From: Charlie Bauman <charlie@gtcptl.com>
Sent: Friday, April 17, 2026 2:23 PM
To: PlanningCommission
Subject: April 22nd Planning Commission Meeting - Bel-Red LUCA
Attachments: April 22 - PC Comment Letter.pdf

Re: April 22nd PC Meeting: Bel-Red LUCA + Street Grid

Subject: Comment on BelRed Look Forward LUCA for April 22, 2026 study session pertaining to land use districts, mixed-use land use district standards, and street network

Re: Bel-Red Subarea Code Update — Transportation and Street Grid Concerns

Site Impact Analysis; ECA and Proposed Roadways

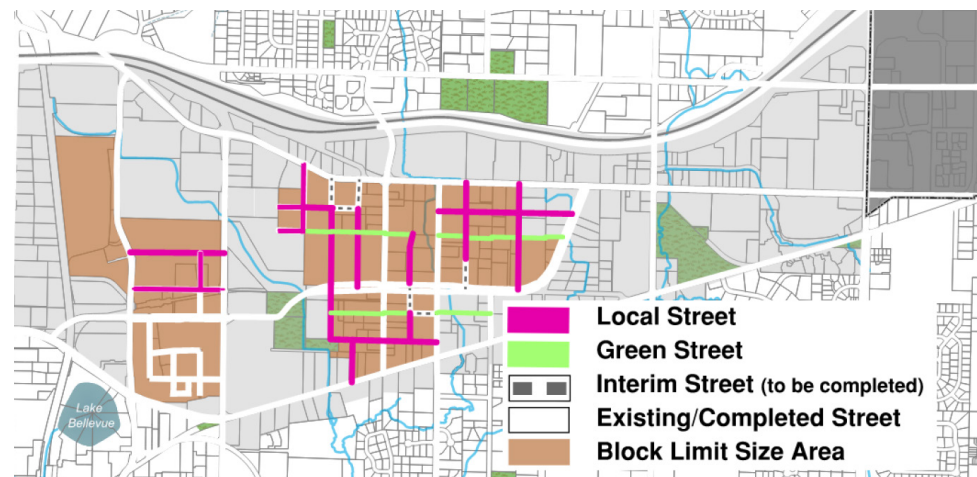
We also ask the commission to consider if any street is needed N-S across our site. Both our site and the site to the west are small sites that will lose significant developable area to any street alignment. In our site's case the area available for redevelopment is being cut down to half or less of the total site area, squeezed between the proposed street and the critical areas associated with Golf Creek. This makes it unlikely market driven redevelopment of our building and site will occur as the existing structure will retain a higher value as is even under the new code.

See the attached study, showing the 50,528 SF site may only retain 11,300 to 24,500 SF of usable area before addressing fire access.

In short, we think the plan for the proposed 131st Street needs to be developed in much more detail so that is feasible from an engineering

standpoint and economically possible. One option to consider is having 131st terminate to the south of our site.

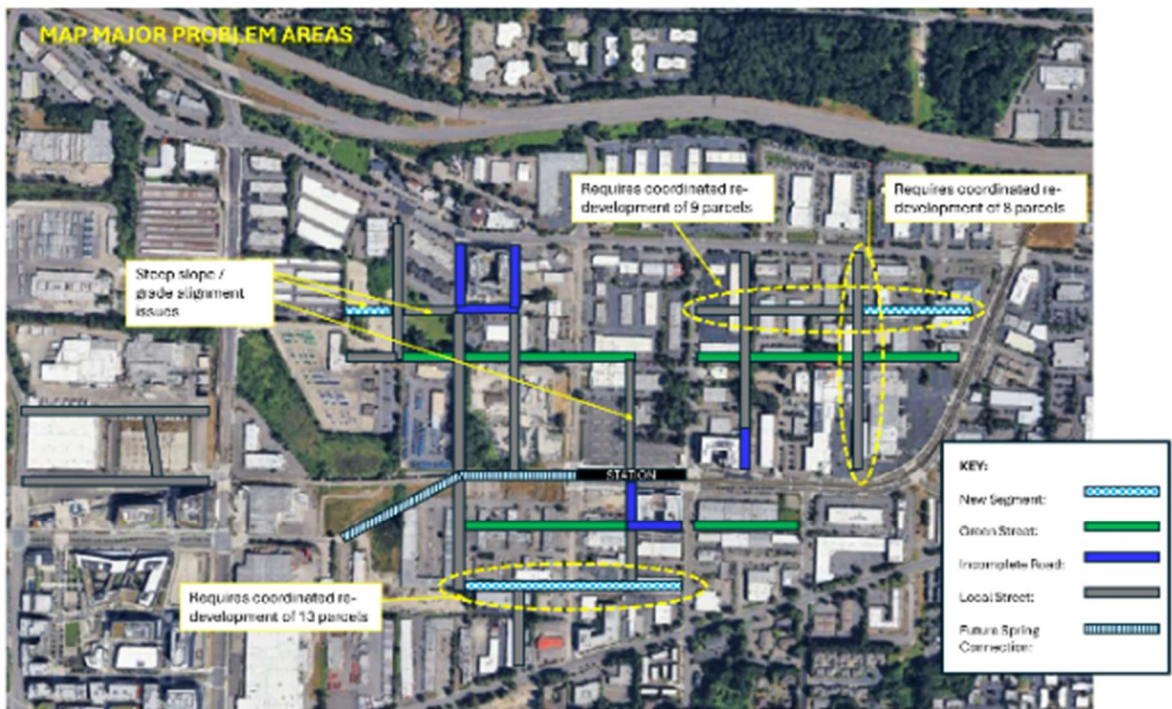
We also call the Commission's attention to specific locations where the street grid alignment as currently mapped would run through environmentally constrained areas (steep slopes, streams, critical areas), are not feasible due to existing access easements, or would bisect small parcels to the point of making them entirely undevelopable. Requiring property owners to build roads that physically cannot be constructed — or that terminate directly into a light rail station — is not a reasonable standard. These examples were previously presented to the City; they remain unresolved in the current draft. We have attached the map showing locations where these constraints are present.

The examples above illustrate just a few of the locations where the proposed street grid creates significant feasibility challenges, driven by extreme grade changes, parcel size, and configuration
